Silverstream Hydraulic Model Peer Review

Date: February 2018
Reference: Remg170914
Status: Final

Opus have been asked by Waimakariri District Council (WDC) to undertake an independent peer review of the Silverstream hydraulic model and associated reporting by DHI. This includes a technical review of the model itself, as well as a peer review of the work undertaken.

Figure 1 – example of different flood frequency distributions overlaid on observed annual maxima data

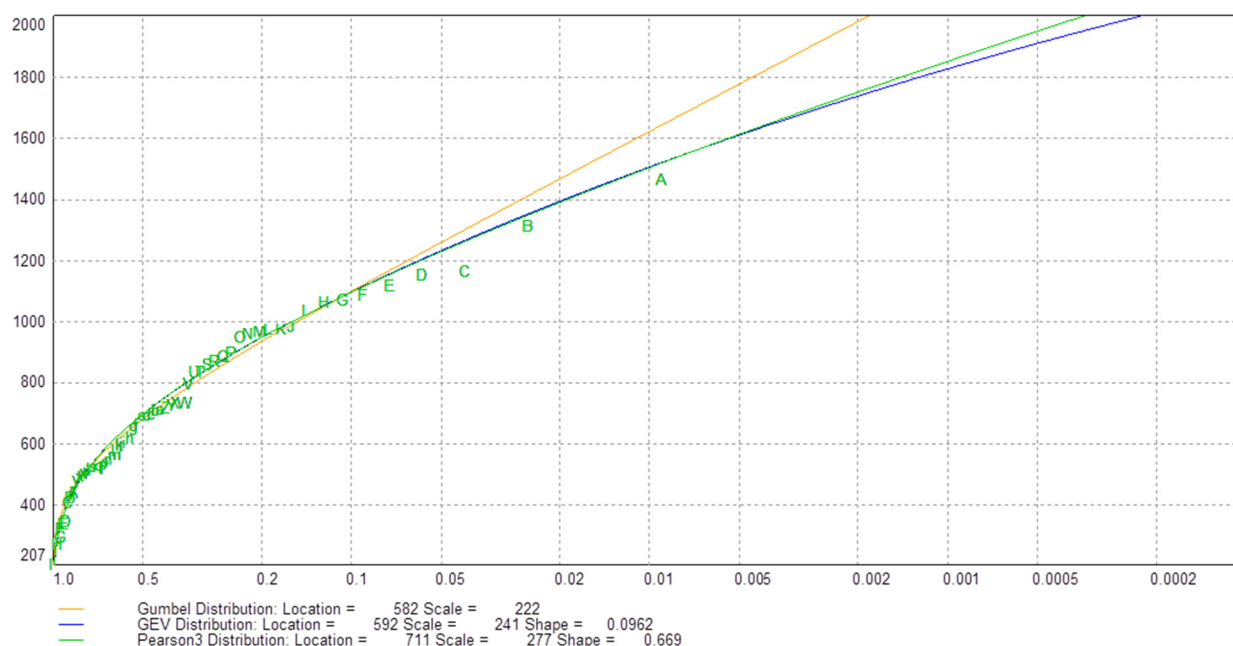
An example below (using a different data set) shows that a GEV or Pearson3 distribution can provide a better fit with the observed data than the Gumbel distribution. Whilst there is precedent that the Gumbel distribution is considered appropriate for Canterbury Rivers, in our view engineering discretion is required for each assessment.

Our view is that use of the Gumbel distribution could over state flood risk compared to other valid distributions. The DHI assessment has selected the upper range values rather than assessing a range of values (sensitivity analysis) to reflect uncertainty over the hydrology.

Best practice would typically involve using a number of established methods and applying judgement as to which provides the best fit. Outliers like linear lines or exponential curves would be discarded, particularly if they result in a poor R^2 value at the upper end of the distribution.

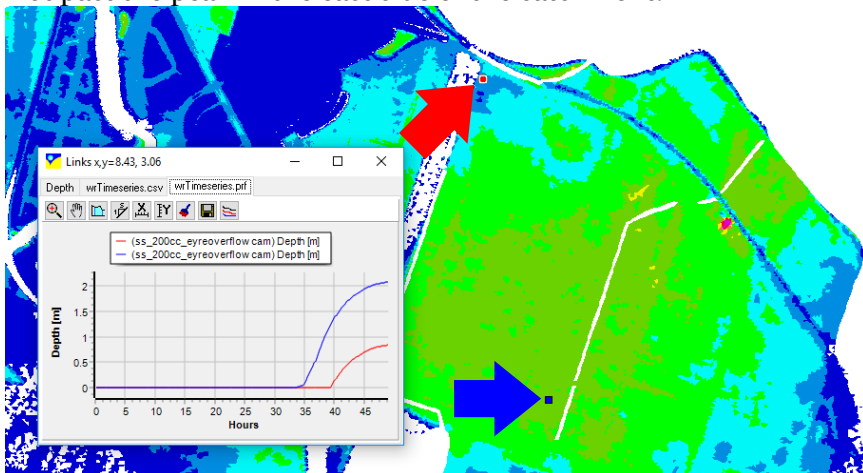
• Concrete (normal)	M=75 (n=0.013)	OK, though concrete may be slightly too smooth
• Concrete (smooth)	M=85 (n=0.0117)	
• Plastic	M=80 (n=0.0125)	
Long section	Sampled long sections generally ok, though there is a jump in Stage2_MH_T3	OK, look at pipe invert at Stage2_MH_T3
Boundaries	None	OK
Simulation duration	31 days	OK
Simulation timestep	31 days	OK, controlled by MikeFlood
